# Access Compliance Report

## Public Rights-of-Way

### (Curb Ramps)

Intersection ID: 49647	Main Street: STRAWBERRY_LN	Cross Street: GREENBRIAR_HILLS_PLANTATION_RD	Location: NW
ADA ID: 2CB4BD592F0B	Ramp Type: PerpDiag	Initial Pass/Fail: Pass	Overall Compliance: No
		Severity Score: 10

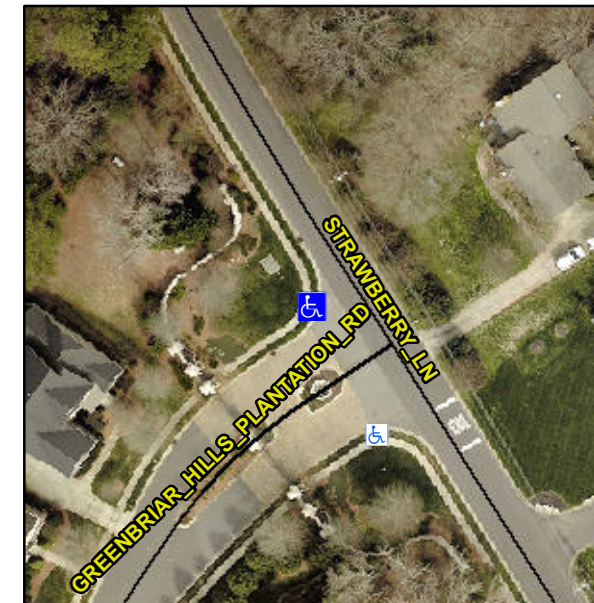
**Not Found, R304.2.1, R304.2.2-Perp, R304.3.2-Para, R304.5.3, R305.2**

**Remove & Replace Curb Ramp With Two New Directional Ramps or Equivalent.**
